**Whitebox Student Campus, Groody Road, Newcastle, Castletroy, Co. Limerick**  
Groody Developments Ltd.  
**Traffic and Transport Assessment (TTA) Report**

Coakley Consulting Engineers  
January 2025

This report was prepared in response to a request from Mr. Brian Coakley of Coakley Consulting Engineers, on behalf of Groody Developments Limited to provide a Stage 1 Quality Audit of the proposed Whitebox Student Campus at Castletroy, Co. Limerick.

### 2.1 Pedestrian Desire Lines within the Development

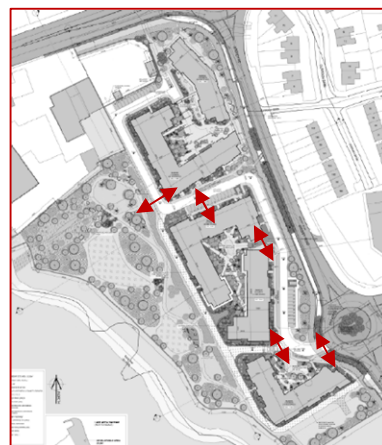
Pedestrian crossings have not been indicated at pedestrian desire lines within the development. No pedestrian crossings have been indicated at the following locations:

- Between the central public open spaces and the surrounding residential development/.
- Between parking spaces and the footpath on the opposite side of the road.
- At the development access and internal vehicular accesses.

A failure to provide an appropriate crossing for non-motorised road users at these expected desire lines could result in difficulties when crossing the carriageway, particularly for mobility and visually impaired pedestrians.

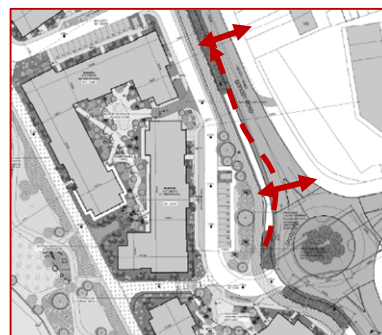
Pedestrian facilities should be provided on Groody Road, including a footpath on the western side of the road and pedestrian crossings, with dropped kerb and associated tactile paving, to cater for pedestrian desire lines.

## 2.3 Steep Gradient

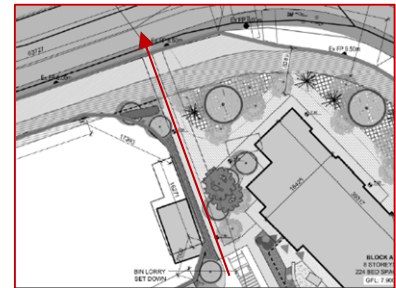
Ensure the proposed ramp gradients are suitable for all road users.

## 2.4 No Dropped Kerb/Tactile Paving at Accessible Parking Spaces

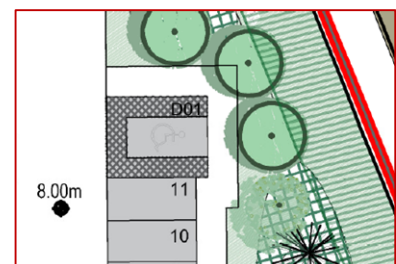
Dropped kerbs, and tactile paving, should be provided adjacent to accessible parking spaces.

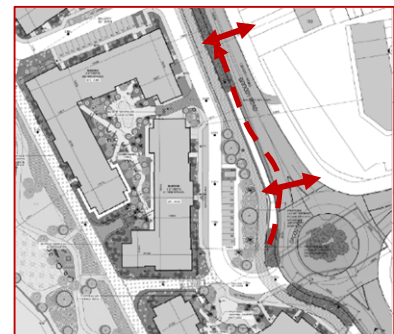
It is likely that pedestrian desire lines will exist between the proposed development and the neighbouring residential area to the east on the opposite side of Groody Road. Two pedestrian accesses to the proposed development have been indicated on Groody Road, however, no footpath is currently provided on the western side of Groody Road nor are any pedestrian crossings provided, or proposed, connecting the development with Curragh Birin, including at the Groody Road/Curragh Birin roundabout.

If pedestrian facilities, including footpaths and formal pedestrian crossings, with dropped kerbs and tactile paving, are not provided on Groody Road, this may lead to difficulties for pedestrians, particularly the mobility and visually impaired, such as wheelchair users, in independently navigating the road layout.

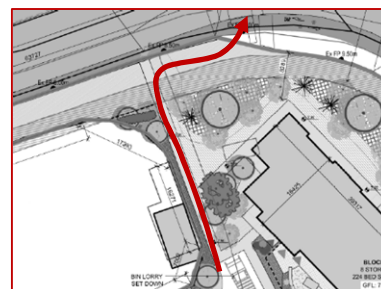
Existing cycle facilities and a Zebra crossing are provided on Dublin Road connecting the University of Limerick with Groody Roundabout. Whilst a pedestrian access onto the footpath on the southern side of Dublin Road has been indicated at the northern boundary of the proposed development, a route, and access, for cyclists has not been indicated at this location.

It is, therefore, likely to result in cyclists travelling within the footpath between Dublin Road and the development. The width of the proposed pedestrian route at this location would be insufficient for use by both pedestrians and cyclists resulting in conflicts between these road users.

*Location: Drawing no. PP-1.01*

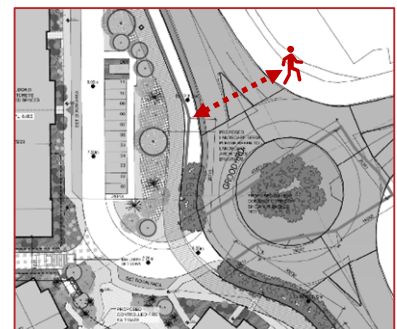
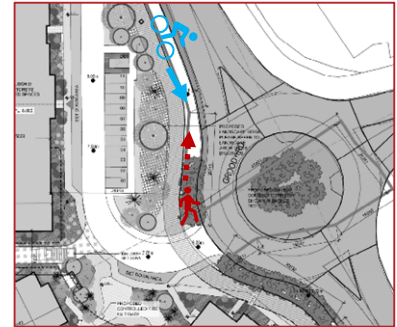
*Summary: No pedestrian crossings have been indicated to/from the proposed development on Groody Road.*

It is proposed to construct the student accommodation development on the western side of Groody Road with two pedestrian accesses indicated onto this side of the road, however, there is currently no footpath along the western side of Groody Road with an existing public footpath provided along the opposite side only. A pedestrian crossing has not been indicated on Groody Road with the nearest crossing being the Zebra crossing at the Groody Roundabout approximately 200m to the north.

Measures should be provided to support the safe movement of pedestrians between the proposed development and developments on the eastern side of Groody Road.

### 3.3 Provision of Crossings

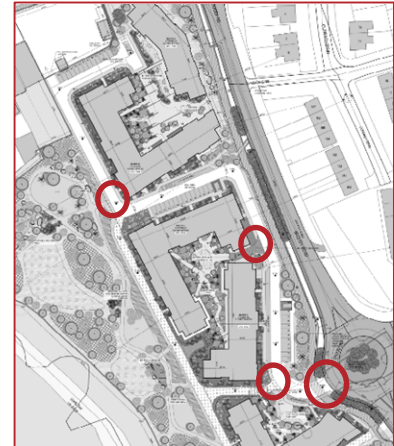
*Summary:* Details of pedestrian crossings within the development have not been indicated.

*Location:* Drawing no. PP-1.01

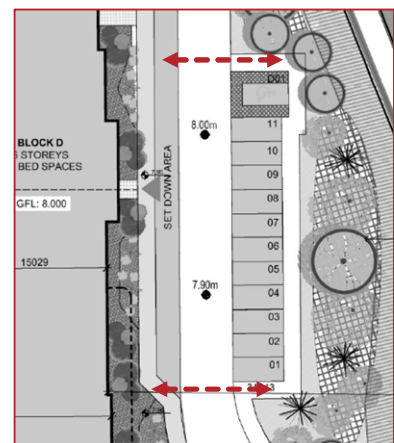
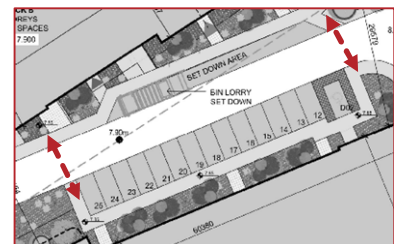
*Summary:* No pedestrian crossings have been indicated to cater for vehicle occupants travelling between their vehicle and the apartment blocks within the proposed development.

Parking spaces have been indicated within the proposed development on the opposite side of the development access road to the main entrance to Blocks B and D. Formal pedestrian crossings have not been indicated adjacent to these parking spaces to accommodate vehicle occupants crossing between their vehicle and the apartment blocks. A failure to provide a formal pedestrian crossing, with dropped kerbs and tactile paving, at these locations could lead to pedestrians, particularly mobility impaired pedestrians, being unable to safely and independently enter the carriageway to cross to the opposite footpath.

### 3.6 Restricted Forward Visibility at Bends

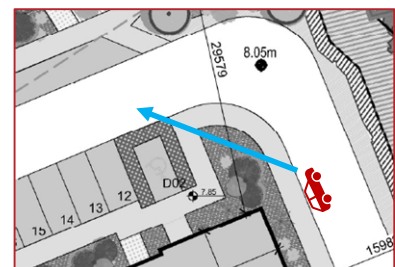
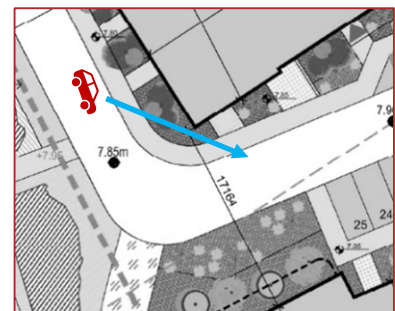
**Summary:** *Forward visibility of drivers within the proposed development may be restricted by proposed planting and building boundaries on the inside of horizontal curves.*

*Location:* Drawing no. PP-1.01

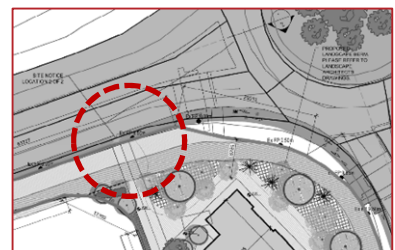
*Summary:* The existing level difference between the site and the adjacent public footpath on the southern side of the R445 may result in a steep gradient on the proposed pedestrian path between the R445 and the development.

A pedestrian route from the proposed development to the footpath on the southern side of the R445 has been indicated at the development's northern boundary. At the time of the site visit, the Audit Team noted a level difference between the development site and the footpath on the R445. It is, therefore, unclear if the gradient of this access path would be suitable for all pedestrians, particularly the mobility impaired. If not, this may increase the risk of slips, trips and falls and personal injuries.

The access path should have a smooth, non-slip surface and should provide a gentle gradient that can be safely traversed by all road users.

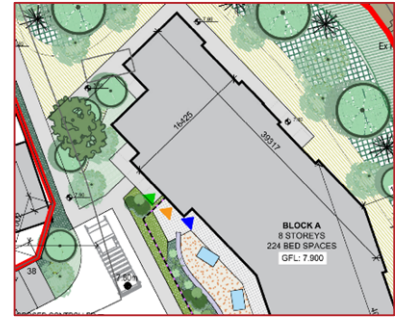
- 4.1 The Main Lobby Entrances have not been indicated at Blocks A and C. It is, therefore, unclear how pedestrians will access these blocks, i.e. from the development's internal footpath network or from routes between other apartment blocks. The Main Lobby Entrances should be clearly marked on the drawings and sufficient routes provided to these locations.
